CITY OF ALBUQUERQUE

RE: Lamar Albuquerque, 1600 Airtech Court SE Grading and Drainage Plan Engineer's Stamp Date 6-17-2015 (File: M16-D024J1)

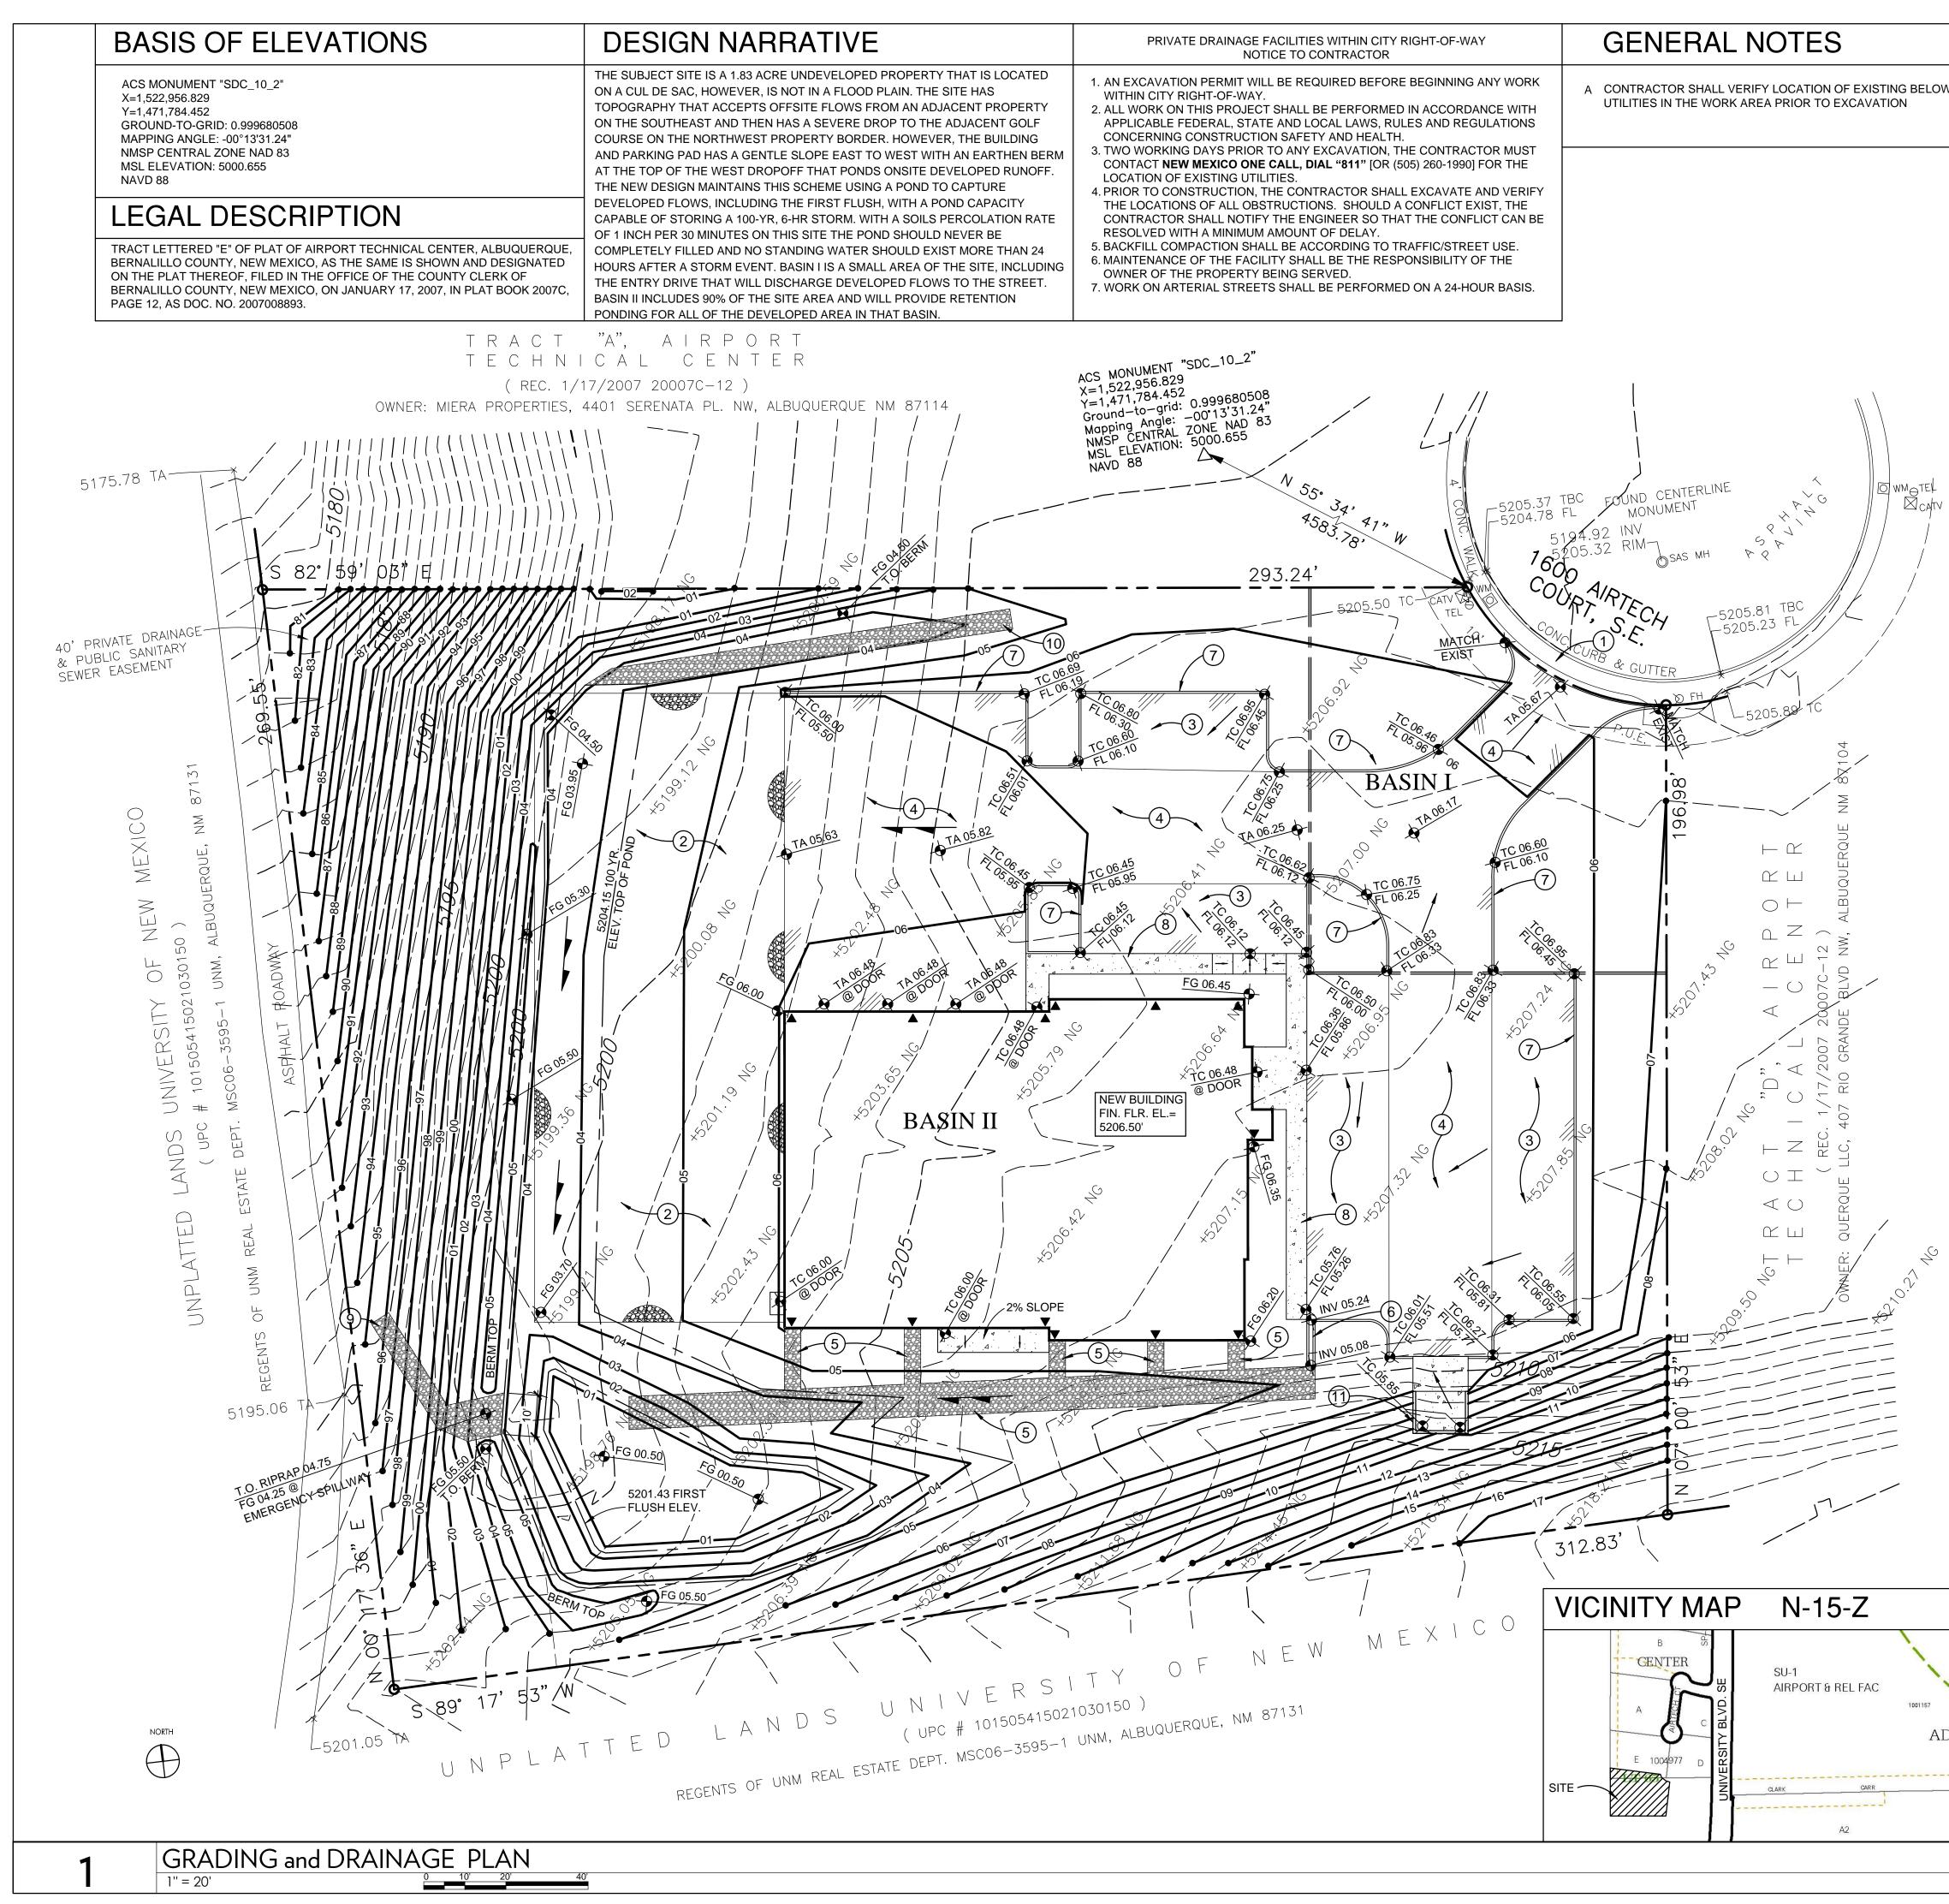
PO Box 1293 Based upon the information provided in your submittal received 6-17-15, the above referenced plan is approved for Building Permit. Please attach a copy of this approved plan in the construction sets when submitting for a building permit. Also, please have an Erosion and Sediment Control Plan approved prior to Building Permit approval.

Albuquerque Prior to Certificate of Occupancy release, Engineer Certification per the DPM Checklist will be required. Additionally, it will be required to submit any construction work within COA right-of-way through the DRC Process.
